Re: PA22-017 – Marysville 172 – Technical Review 1

After preliminary site plan review of the above referenced proposal, the Planning Division has the following comments:

PRELIMINARY SITE PLAN

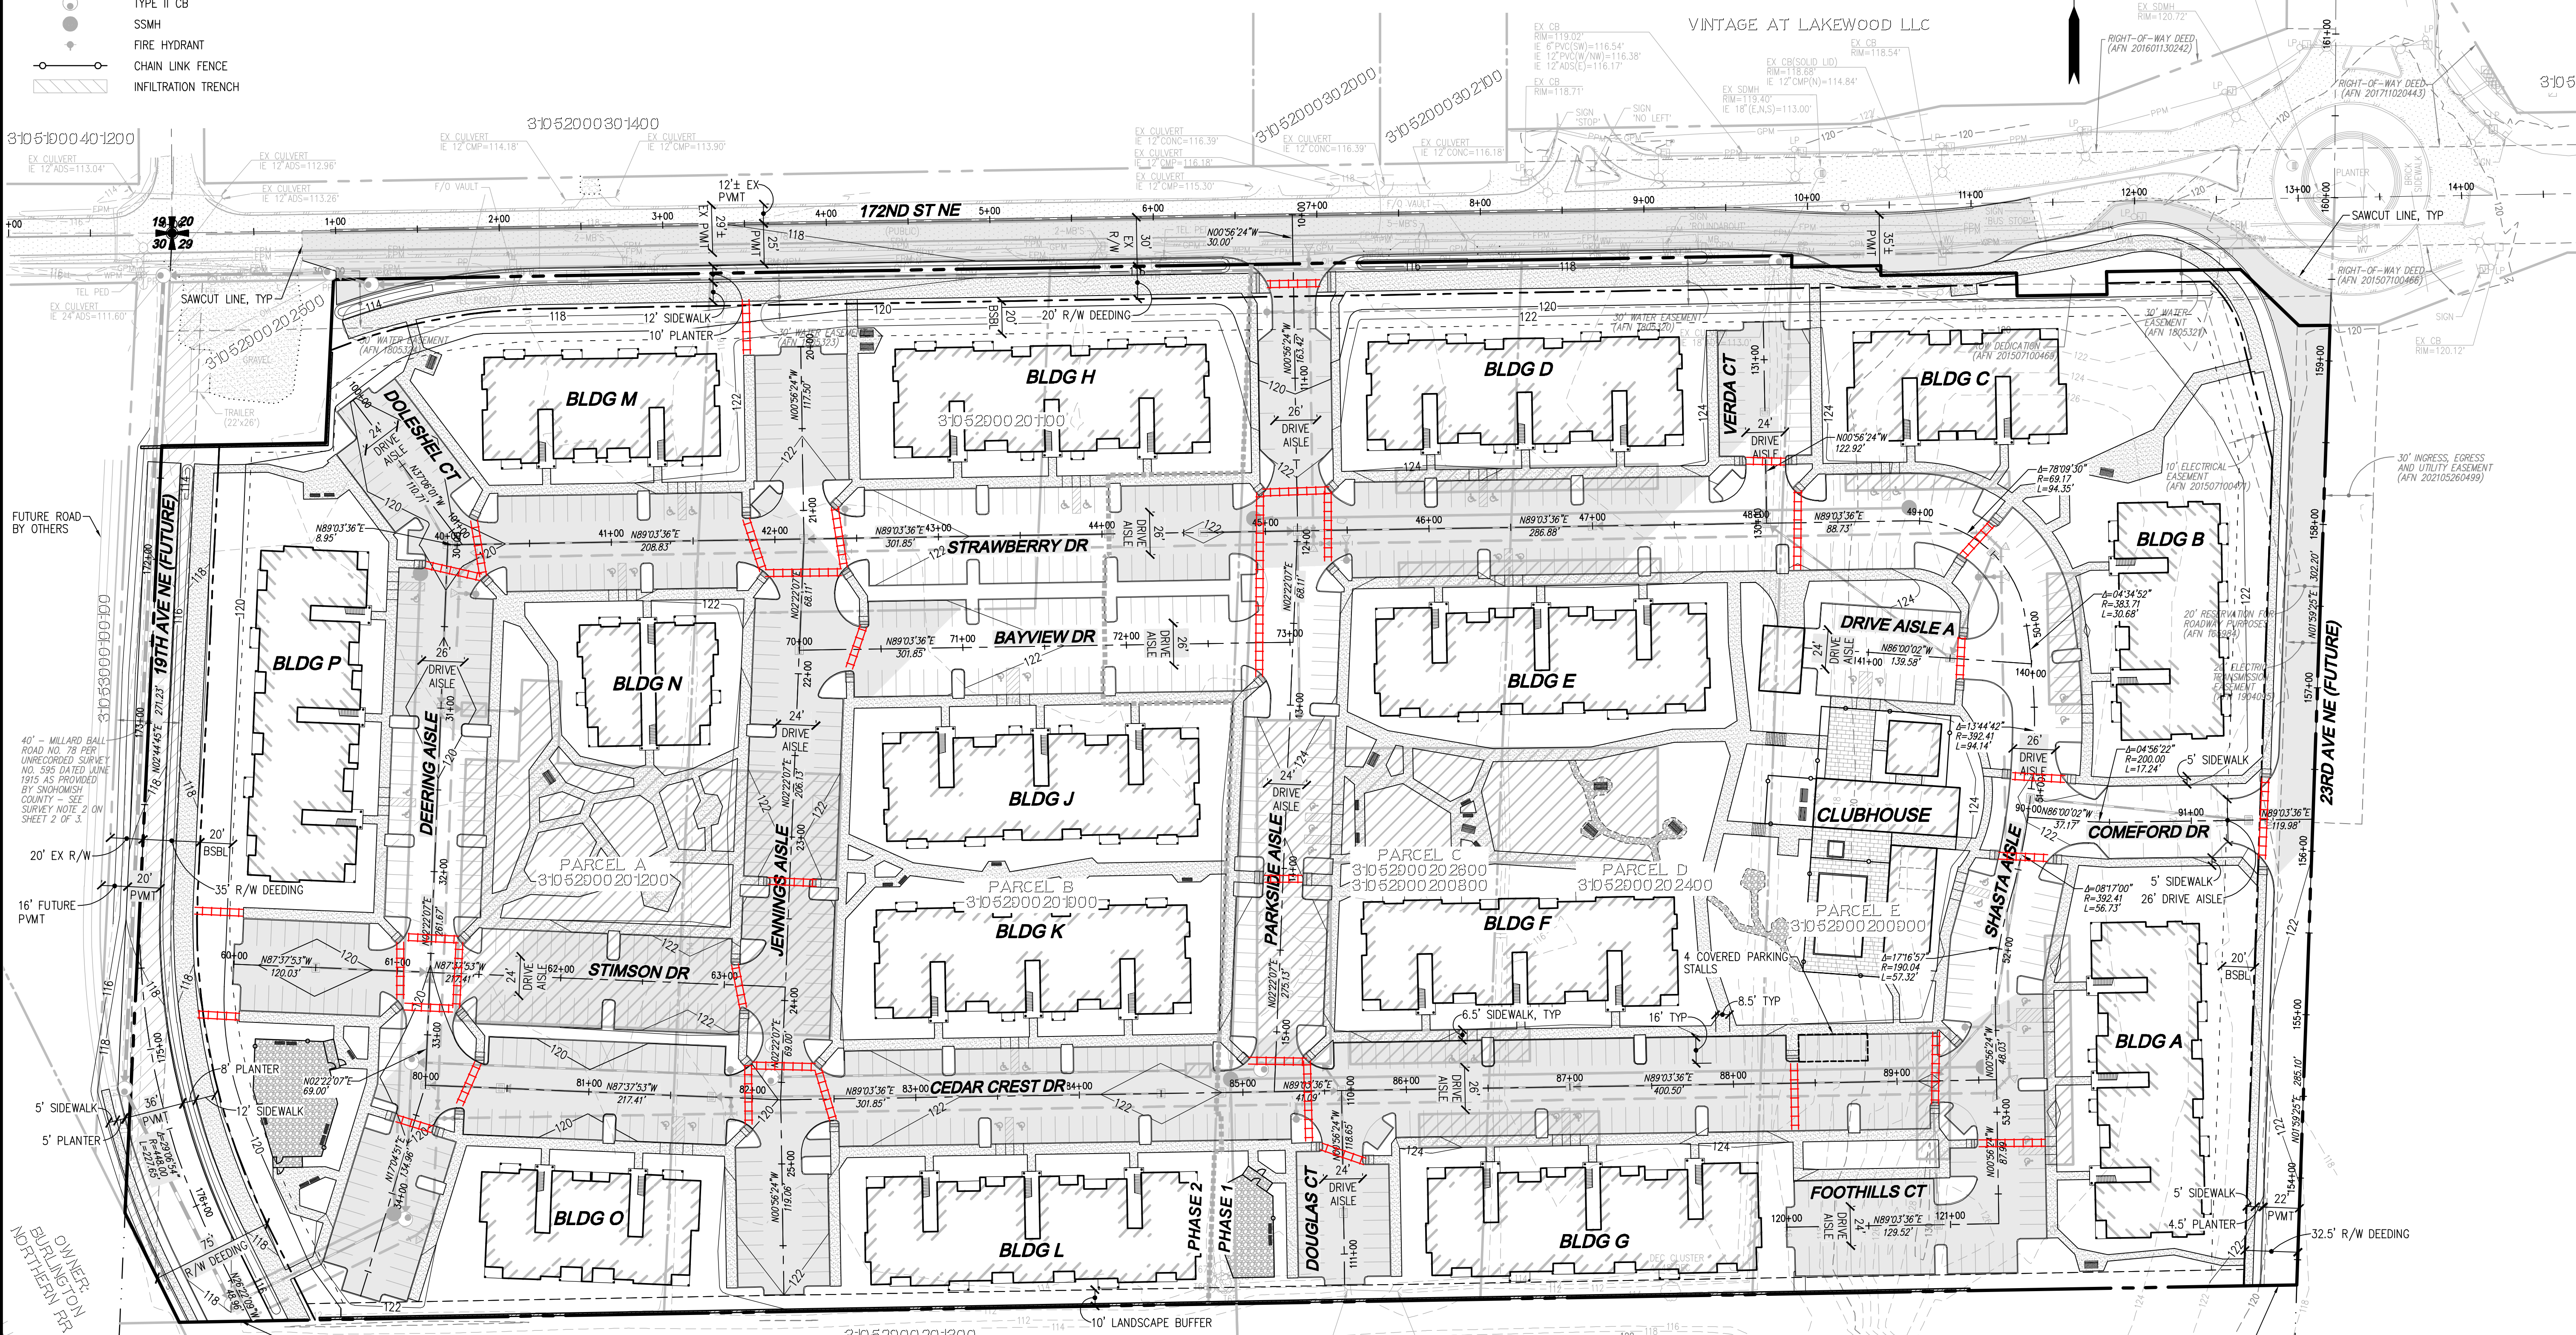
- 2.16. B.12 Street Connectivity
- 2.17. B.13 Service Areas and Mechanical Equipment
3. Amend Sheet TO-01, depicting, or referencing, if unable to depict the following encumbrances outlined in the Title Report:

- 3.1. Seattle and Montana Railway Company easement (AFN 5850); and
- 3.2. City of Marysville waterline easement (AFN 1805322).
4. Amend Sheets ASP-01, ASP-02, SP-01 and all other applicable sheets as follows:

- 4.1. Based on the City's definition for Townhouse vs. Multifamily Dwelling Unit, the proposed development would be considered *Multifamily*.
- The proposed land use stated on CS-01 and SP-01 is *Townhomes*—please revise accordingly.

- 4.2. As referenced on the Civil Plans, the project is to occur in (2) phases. Revise plans to clearly show the dedicated areas of Phase 1 and Phase 2; the existing denotation is difficult to read.

- It appears that Buildings G & L may encroach into the required setbacks. Encourage a greater setback on the south property line, as a required 10 L1 Landscape buffer is required to be provided, which will likely take away all solar access to Buildings G, L & O.

- 4.4. Demonstrate compliance with impervious surface standards (75% maximum). Show calculation and total impervious surface percentages allowed and proposed.

- As referenced on L0.00, the total residential open space provided is 107,529 sq. ft. However, the shaded open spaces areas total 103,084 sq. ft. Please revise and demonstrate compliance by providing these calculations. Further, please clarify which open spaces areas these shaded areas represent.

As mentioned in the Project Narrative and referenced on the Civil Plans, the applicant has proposed less parking spaces than what was shown to be required. Modifications to required parking standards must be approved by the Hearing Examiner. If the applicant wishes to pursue a variance per [MMC 22C.130.090](#), an application for such shall be formally submitted.

4.12. Pedestrian pathways that traverse a parking lot shall be constructed with concrete or other approved decorative surface and must be universally accessible and meet ADA standards. This detail shall be provided on the site and civil plans (see attached redlines).
